From: Jacobson - DNR, Eric <eric.jacobson@state.co.us>
Sent: Wednesday, January 8, 2020 10:32 AM
To: Nick_Rosenhagen@oxy.com
Subject: [EXTERNAL] Re: NESG 11-24 API: 0512323121 - CHANGE OF SCOPE

Based on our current P&A design, I request the following changes of scope on the NESG 11-24:

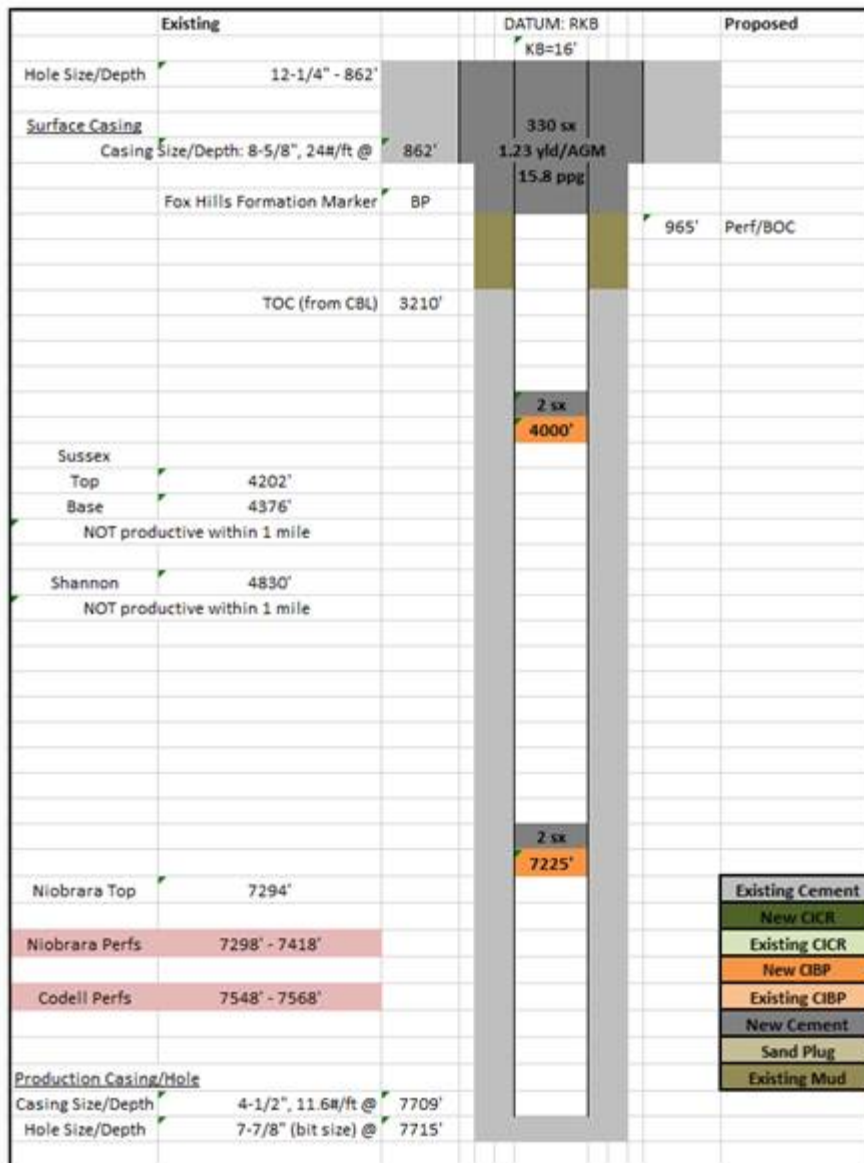
1. Changing the 25 sx Niobrara balance plug to a 2 sx dumpbail
2. Removing the casing cut and stub plug and replacing it with a squeeze to surface from 965'-0'

Below is a WBD that represents the requested changes. Please let me know if you have any questions or concerns.

Approved as outlined.
